Access Compliance Report

Public Rights-of-Way

Intersection ID: 11342	Main Street: GEORGIA_AV	Cross Street: MATHESON_AV	Location: N
ADA ID: 3EB9E86E05F3	Ramp Type: Perp	Initial Pass/Fail: Fail	Overall Compliance: No
Codes/Mitigation Info/Possible Solution		Field Measurements/Component Compliance	
Severity Score: 33.75

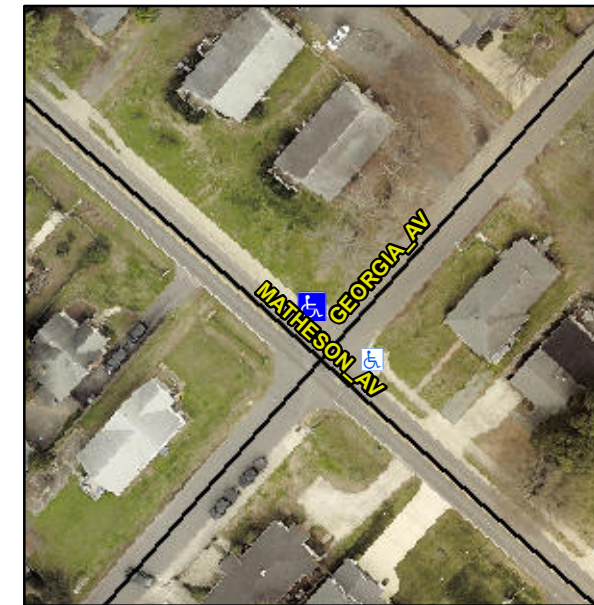
Not Found, R304.5.1, R304.2.2, R304.5.3

Compliance	Description	Data	Compliance	Description	Data
N/A	Ramp Length (in)	73.0	No	Ramp Slope (%)	8.6
No	Ramp Width (in)	41.0	No	Ramp XSlope (%)	6.8
N/A	Flare Type LT	N/A	N/A	Flare Type RT	N/A
N/A	Flare Slope LT (%)	N/A	N/A	Flare Slope RT (%)	N/A
N/A	Flare Traversable LT?	N/A	N/A	Flare Traversable RT?	N/A
N/A	Landing Length (in)	N/A	N/A	DWS Provided?	N/A
N/A	Landing Width (in)	N/A	N/A	DWS Contrast?	N/A
N/A	Landing Slope (%)	N/A	N/A	DWS Length (in)	N/A
N/A	Landing X Slope (%)	N/A	N/A	DWS Full Width?	N/A
N/A	Landing Curb? (Y/N)	N/A	N/A	DWS Offset (in)	N/A
N/A	Shared Landing?	N/A			
N/A	Gutter Ponding?	N/A	N/A	Gutter Slope (%)	N/A
N/A	Gutter Lip Ht (in)	N/A	N/A	Gutter X Slope (%)	N/A
N/A	Painted X Walk1?	No	N/A	Painted X Walk2?	N/A
	X Walk 1 Direction	To SE		X Walk 2 Direction	N/A
N/A	X Walk 1 Width (in)	N/A	N/A	X Walk 2 Width (in)	N/A
	X Walk 1 Slope (%)	2.7		X Walk 2 Slope (%)	N/A
	X Walk 1 X Slope (%)	7.2		X Walk 2 X Slope (%)	N/A

Remove & Replace Entire Ramp.
